APPENDIX D WATER BODY ADDENDUM

Project No. 1230

**Re: Adelaide Wind Energy Centre
Water Body Report Addendum I**

Figure 1

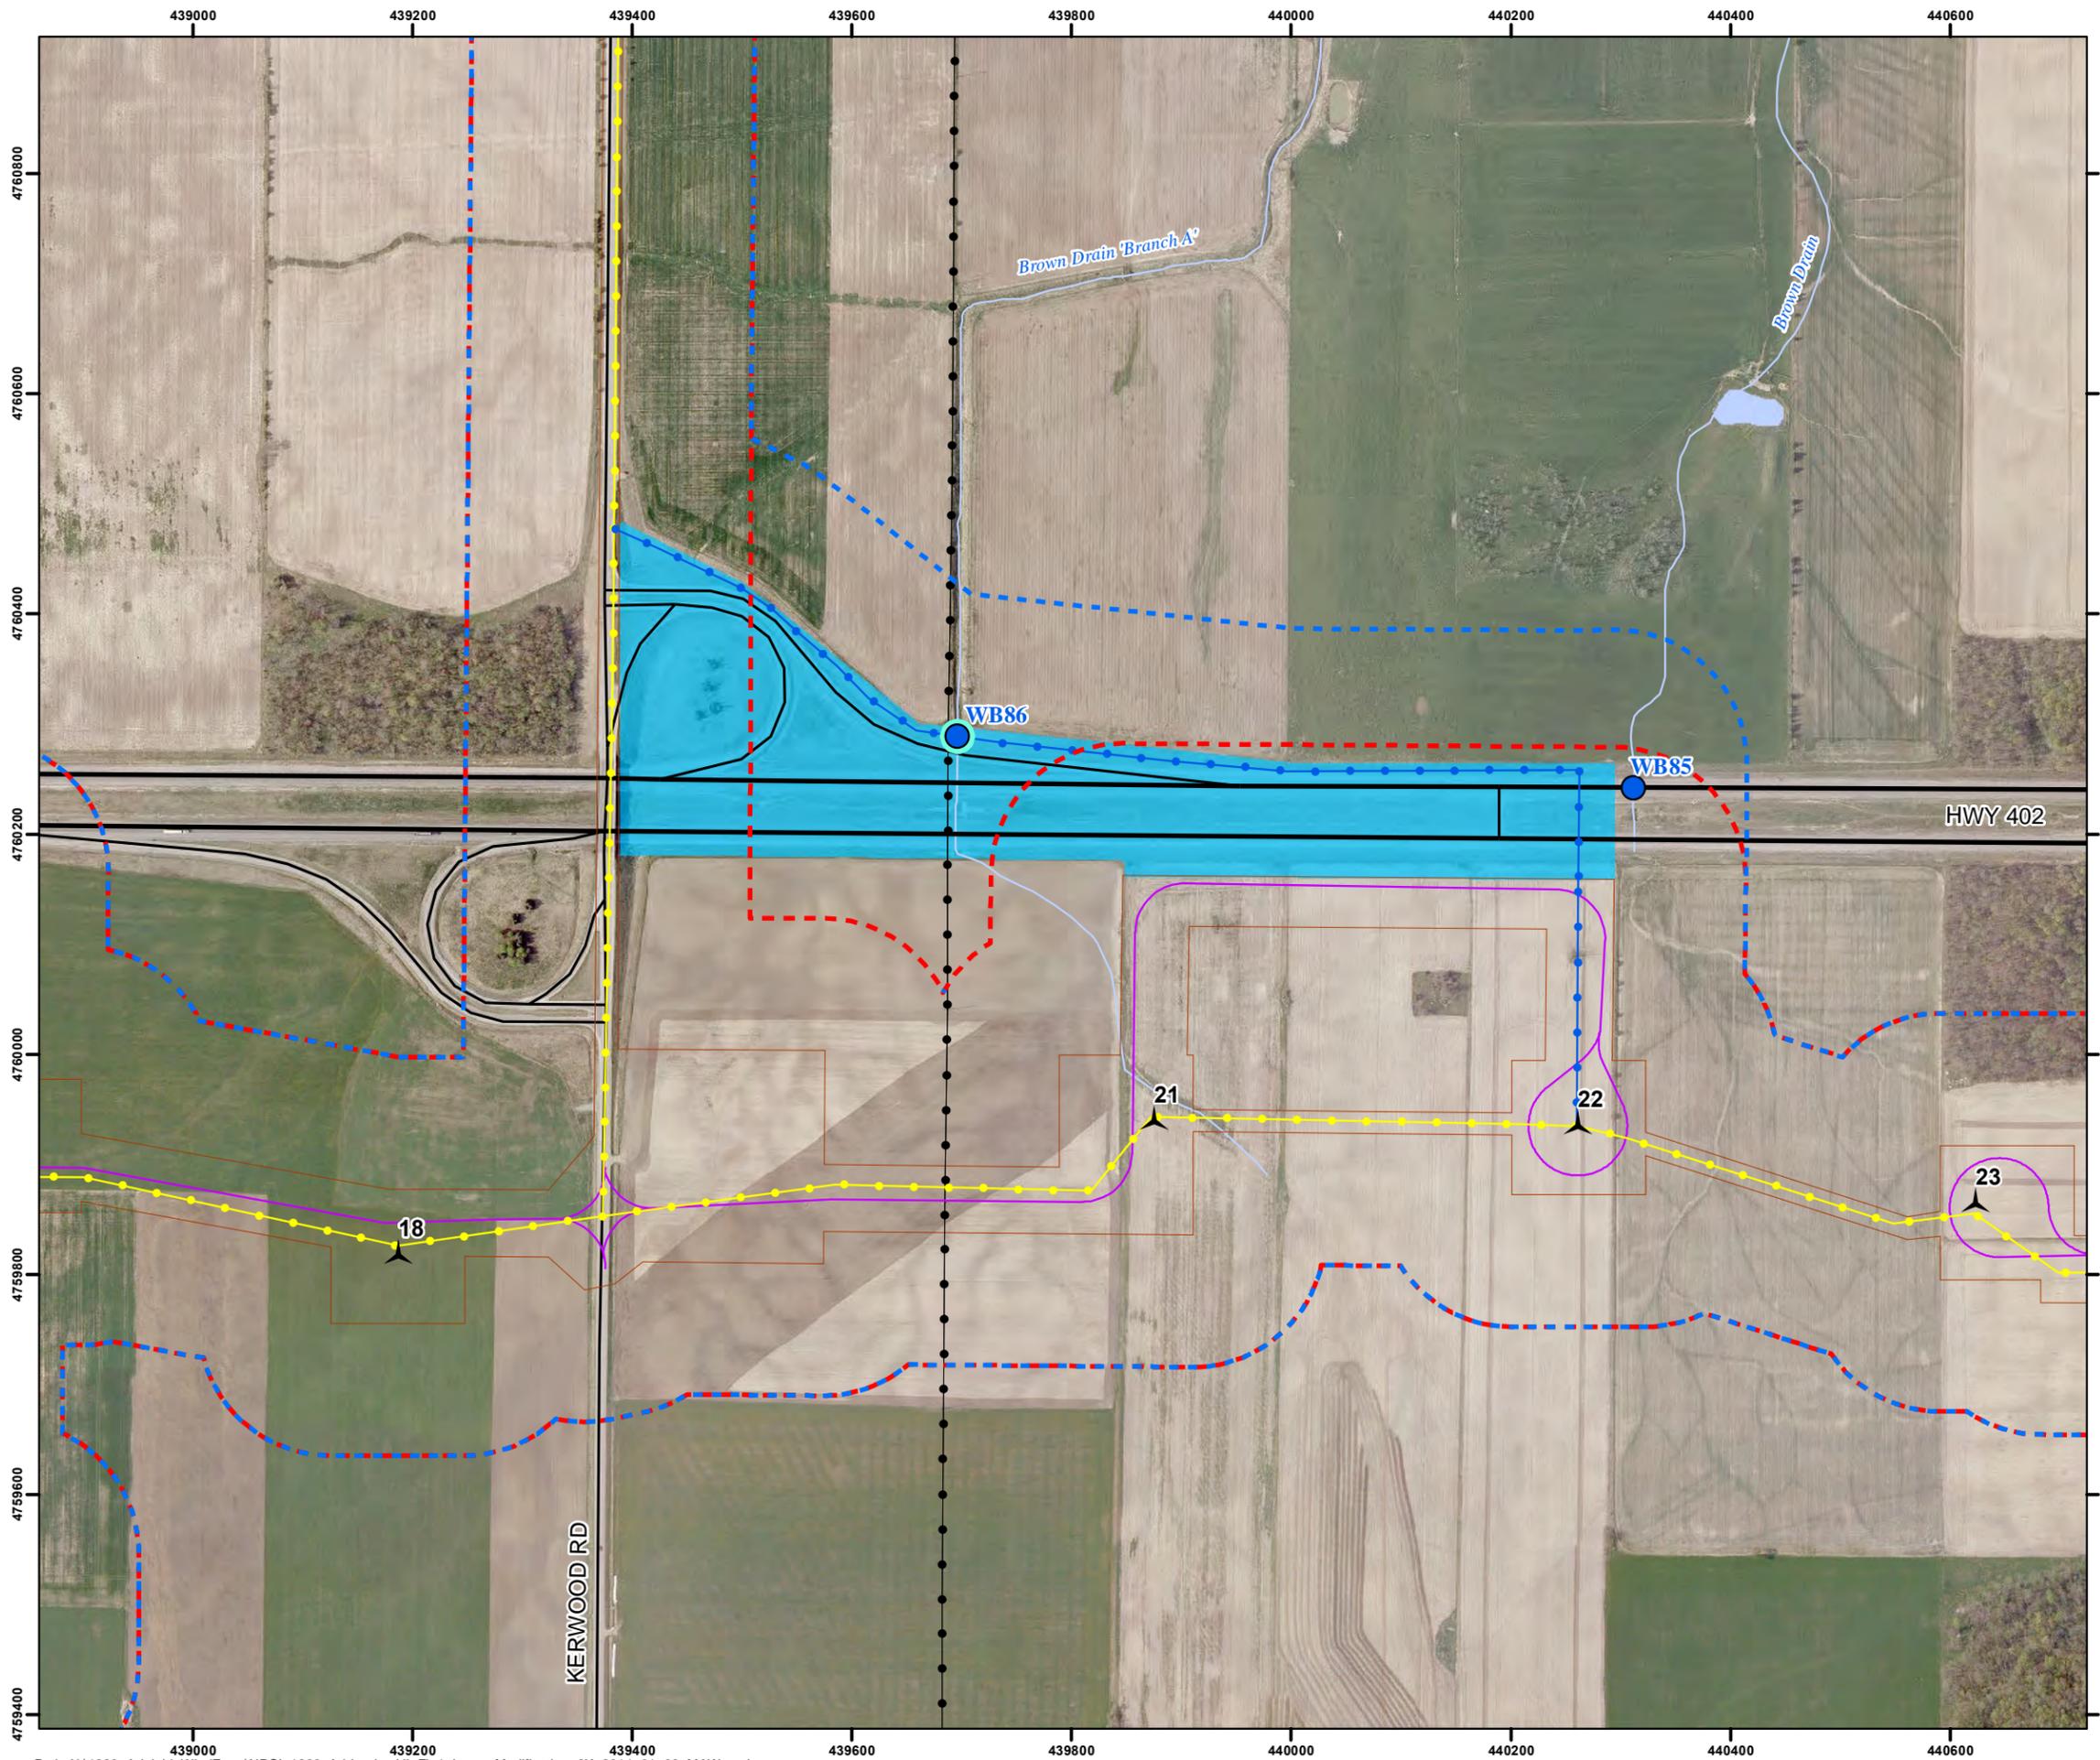
The modification is related to the location of a proposed underground cabling route at the corner of Kerwood Road and Highway 402. The proposed new route will run north from T22 across the 402 and west to Kerwood Road, where it will join up with the previously permitted cabling route. This additional underground cabling will now overlap with one watercourse and will be within 120m of another previously identified watercourse.

A visual overlay of the differences between the project location of the latest approved layout submission and the currently proposed project location of this Addendum Report is provided on Figure 1. Also shown on this figure are the locations of the two watercourses within 120m of the project location and the crossing location of the water body, which will now be overlapped by underground cabling.

NRSI biologists have reviewed the changes in project location, including the overlap of the project location with an additional water body, and have determined that the mitigation measures presented in the Water Body EIS (NRSI 2012) are still adequate for the protection of the water body from permanent and adverse impacts that may result from the development of the Adelaide Wind Energy Centre. Any mitigation measures outlined for underground cabling installation should be implemented at the location where underground cabling is proposed to overlap with Brown Drain Branch A (Figure 1).

Based on the minor changes in project location, NRSI has determined that the monitoring requirements identified in the Water Body EIS are suitable for the monitoring of potential environmental effects of the proposed Adelaide Wind Energy Centre. Any monitoring requirements outlined for underground cabling installation should be implemented at the location where underground cabling is proposed to overlap with Brown Drain Branch A (Figure 1).
